CERTIFICATE OF APPROPRIATENESS**Application Date:** January 6, 2016**Applicant:** Alexander Ridgeway of Brickmoon Design for Cole Patchell, owner**Property:** 1201 Arlington Street, Lot 12 Block 89, Houston Heights East Subdivision. The property includes a historic 1,692 square foot Contributing Brick Bungalow Duplex, a 548 square foot Contributing Garage Apartment, and a 1,147 square foot Contributing Brick Bungalow situated on a 6,600 square foot (50' x 133') corner lot.**Significance:** Contributing Brick Bungalow Duplex constructed circa 1930 and a Brick Bungalow facing East 12th Street located in the Houston Heights Historic District East. A two-story Contributing garage-apartment exists between these two structures. A Certificate of Appropriateness to demolish the garage-apartment was granted in December of 2015.**Proposal:** Alteration – Addition. Revision. The applicant was deferred in January 2016 to connect the rear of a Contributing 1,387 square foot Bungalow Duplex with the east side of a 1,144 square foot Bungalow with a 1,687 square foot addition to create one 4,281 square foot structure.

The applicant now proposes to connect the rear of a Contributing 1,387 square f

EAST ELEVATION – FRONT FACING ARLINGTON STREET

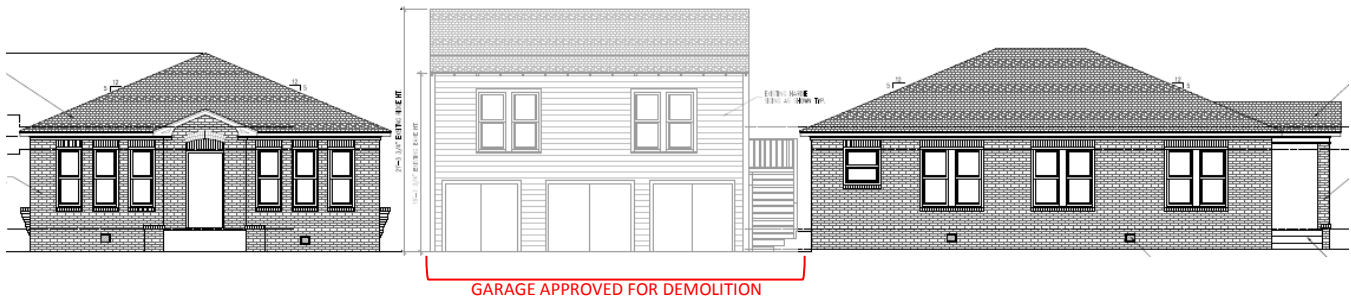
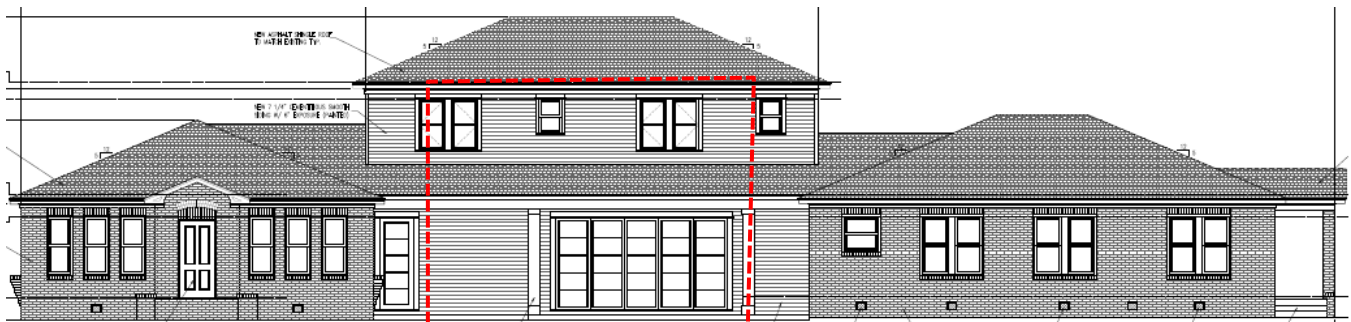
- ☐ ☒ ☐ (10) The proposed alteration or addition must be compatible with the massing, size, scale material and character of the property and the context area;
The proposed addition creates a single large structure, which is of an incompatible size and scale compared to the two smaller separate buildings and other Contributing structures found within the context area.
The proposed addition should be more sensitively attached to the existing buildings, to create a more standalone feature (more closely resembling the development pattern of the existing garage before demolition). A more clear delineation of the three masses could be achieved by separating the addition with gaps between the existing buildings. These gaps can be bridged by simple halls, connecting the original buildings to the addition. The eaves of the proposed connectors should be lower than the existing eaves.

At the January 2016 HAHC meeting staff gave several suggestions to make the proposal more compatible, including revising the addition to limit its size roughly within the footprint of the existing garage apartment that is approved to be demolished; Connect the Bungalow and Bungalow Duplex to the new addition by small hyphens; Not constructing a unifying roof structure over all three structures; Not removing a historic window on the Bungalow; Not bumping the wall out at the rear of the north elevation of the Bungalow Duplex; and Not painting the existing unpainted brick cladding.

SITE PLAN

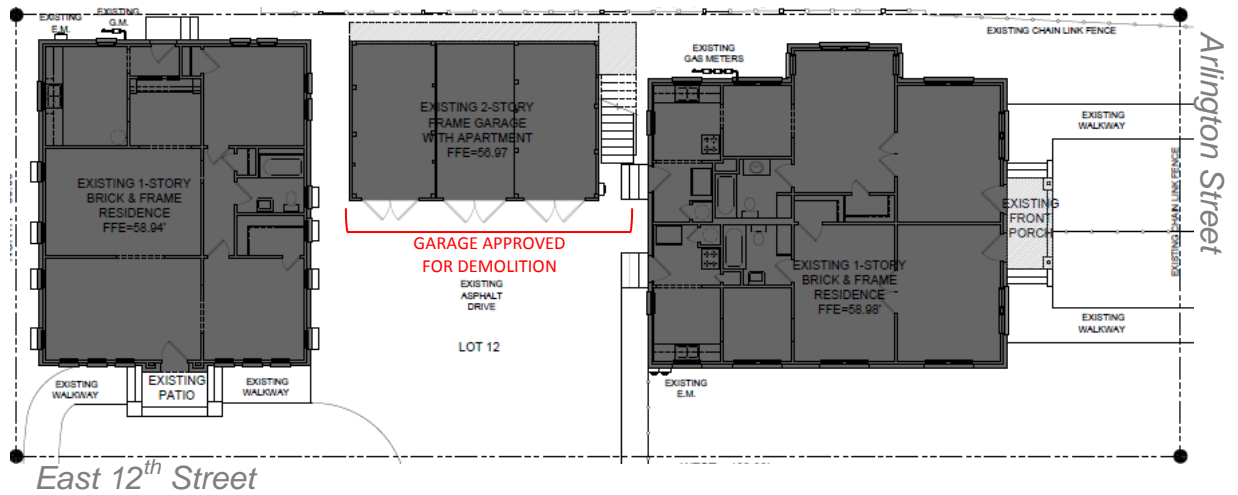
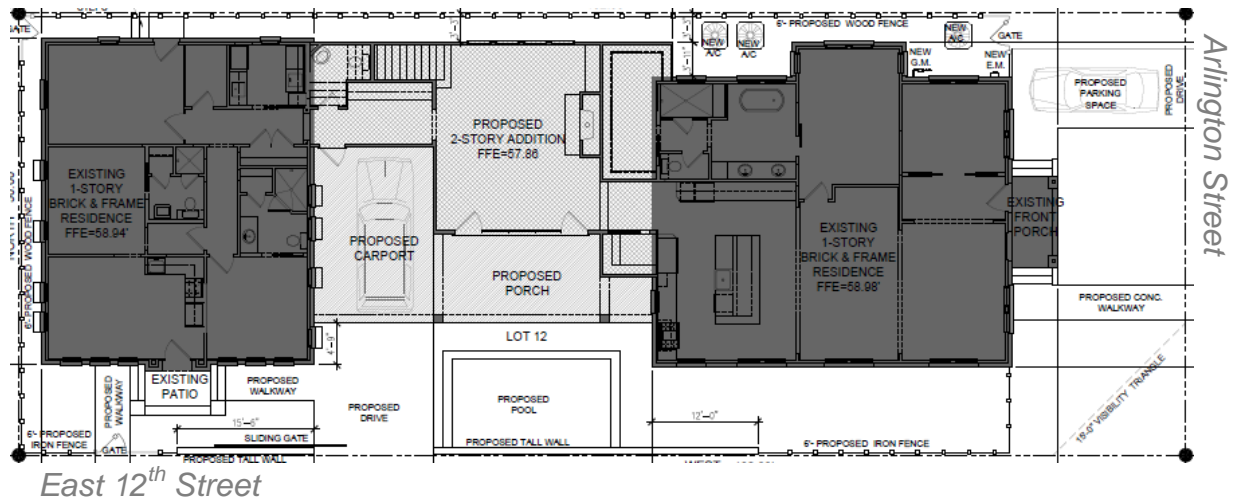
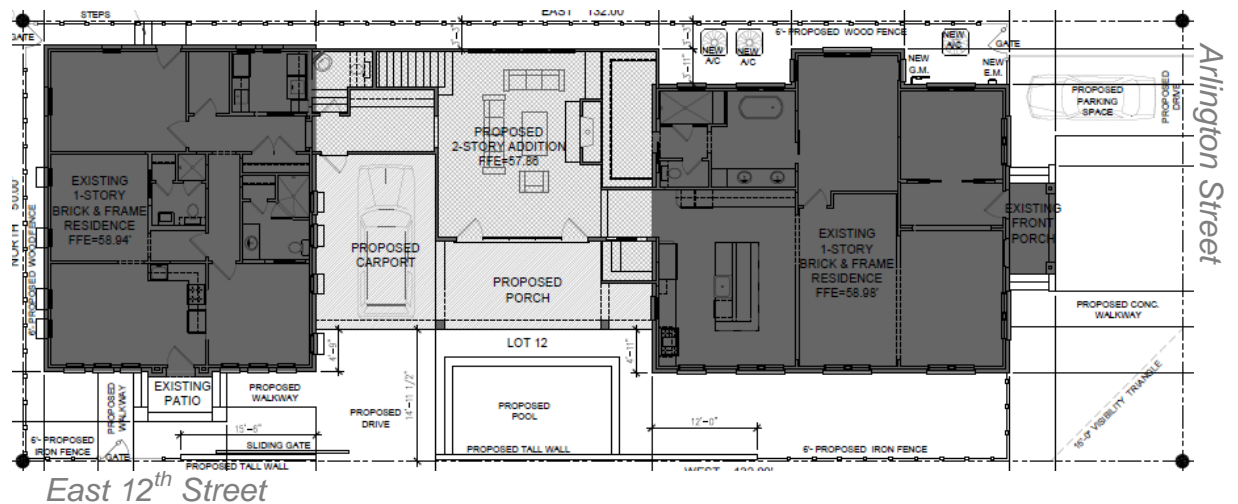
Staff has reiterated to the applicant on numerous occasions, even prior submitting an application, to roughly retain the footprint of the existing garage and to connect all three buildings with small hyphens. As stated above and at the January 2016 meeting, these suggested revisions would result in clearer delineation between the existing and proposed structures.

FIRST FLOOR PLAN

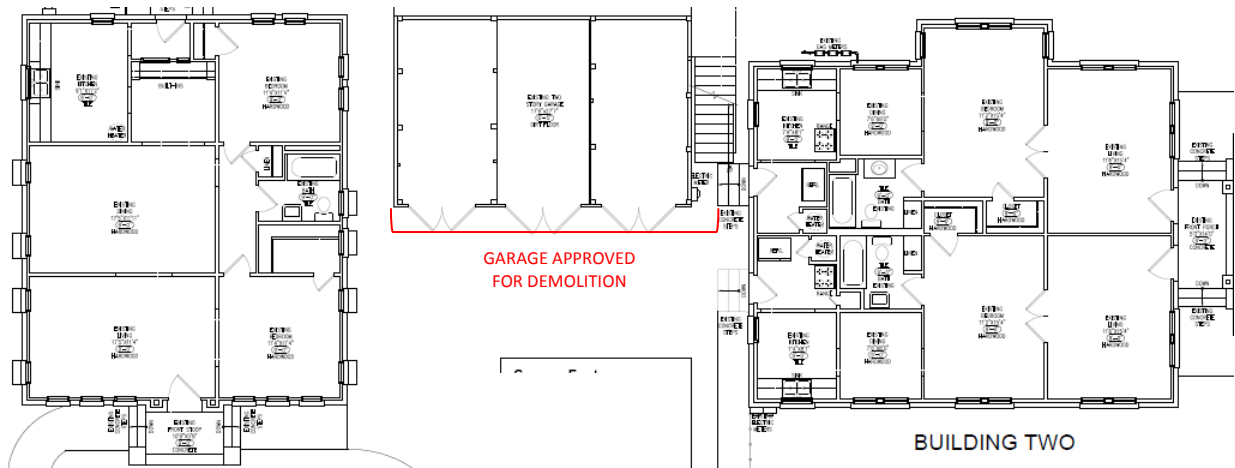
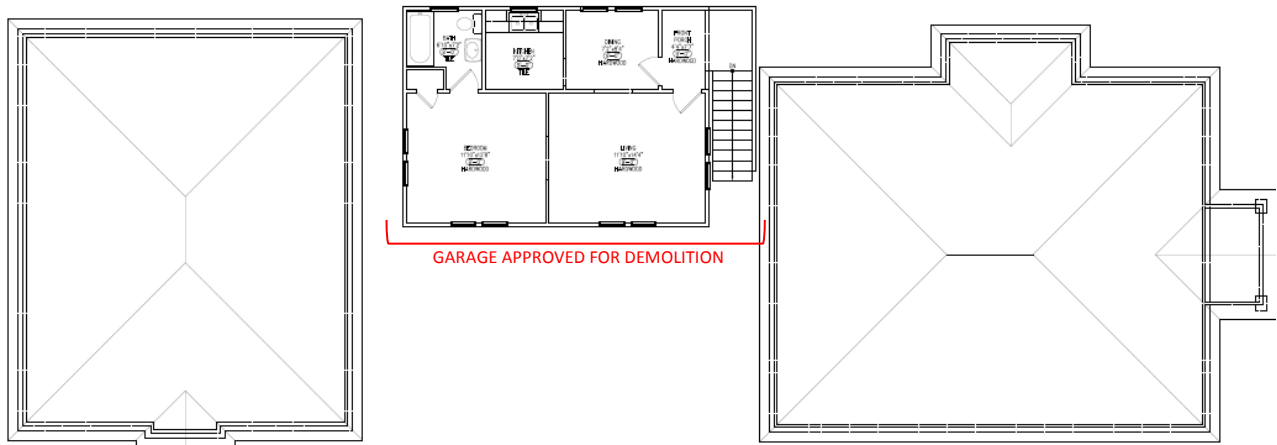
Master closet bump out on the north side of the existing Bungalow Duplex
